Our Ref: 407.00027.00385  
Your Ref: 15/0666/10

**CRAIG YR HESG QUARRY EXTENSION  
RESPONSE TO QUERIES**

# Hanson UK: Craig yr Hesg Quarry

## Dust and Particulate Management Plan and Dust Monitoring Plan

**DMP1**

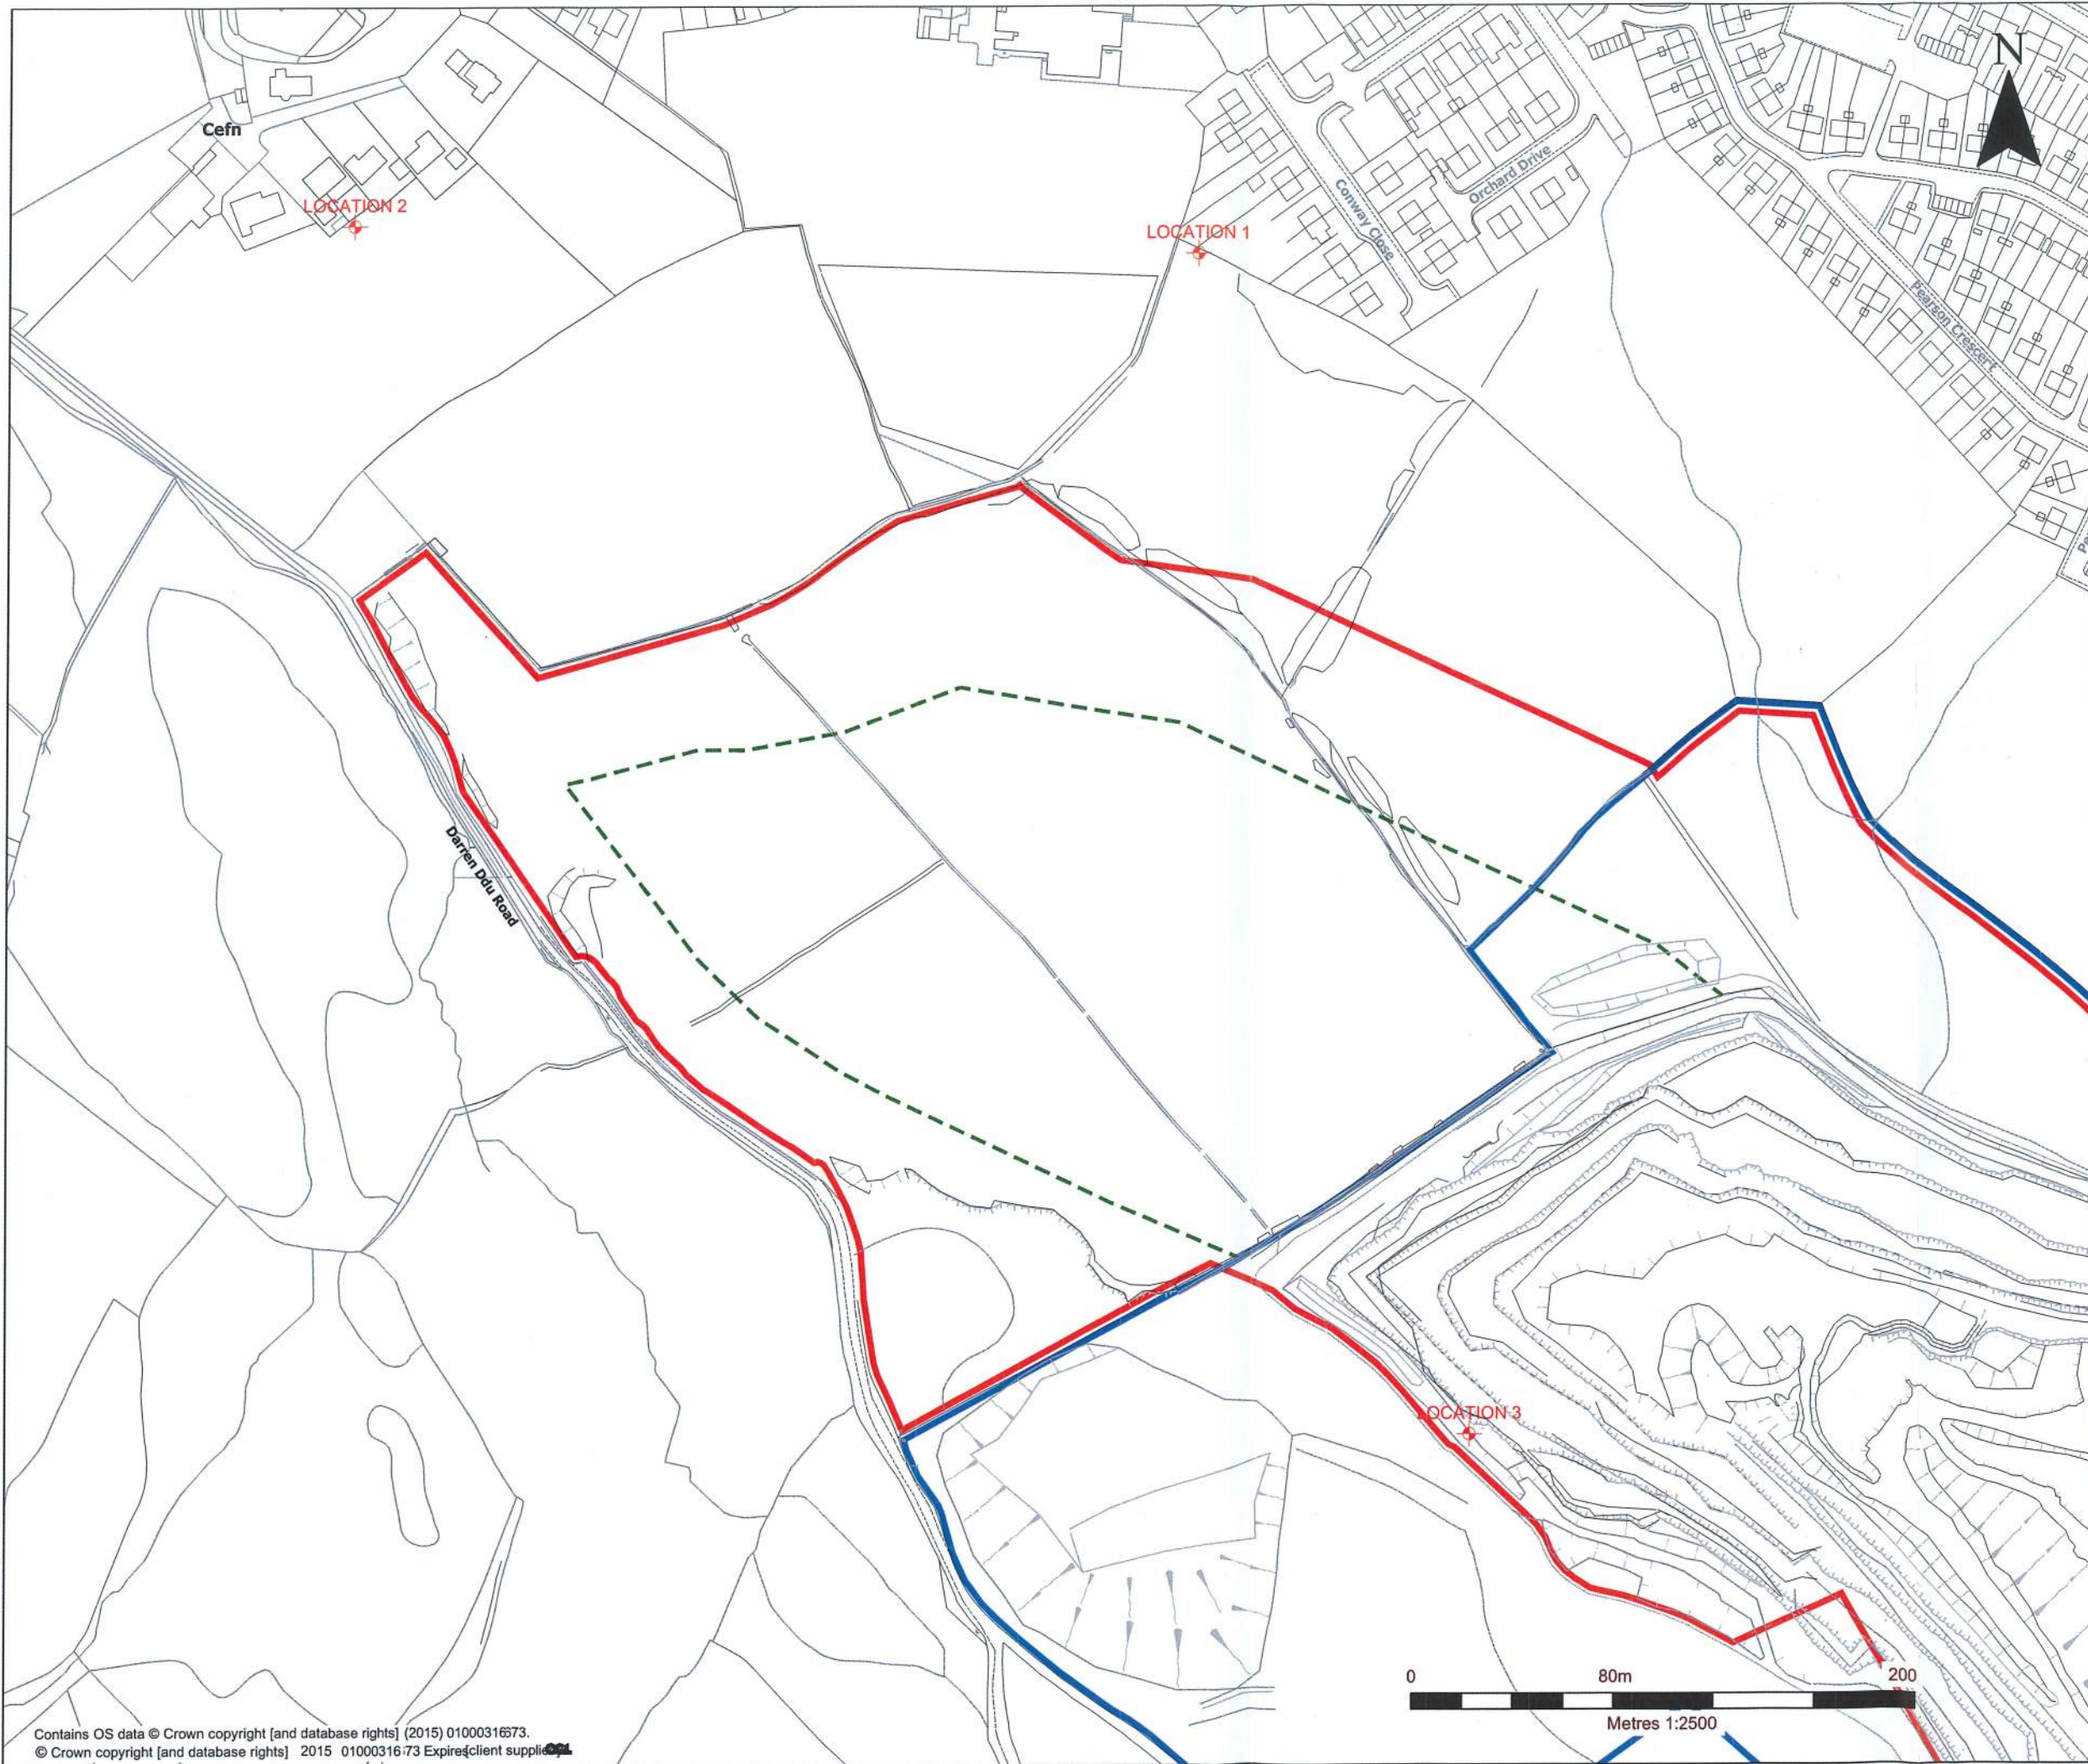
- 3.2 Given that this is the identified key source of potential nuisance dust, it is proposed to monitor fugitive dust at three locations in the vicinity of the extension development / screen bund, as shown on Location Plan DMP1. Location 1 is at the rear of Conway Close and is representative of the closest properties to the extension area and the proposed site for the construction of the screen bunds. Location 2 is to the north of the extension area, close to the properties at Cefn Heulog. Location 3 is to the south west of the quarry extension area and will be used to establish background dust deposition levels. Locations 1 and 3 correspond with locations 4 and 3 respectively on ES figure 12.10 where monitoring was carried out as part of the EIA undertaken in support of the extension/consolidation application and benefit from baseline monitoring data captured in advance of the commencement of the extension development.
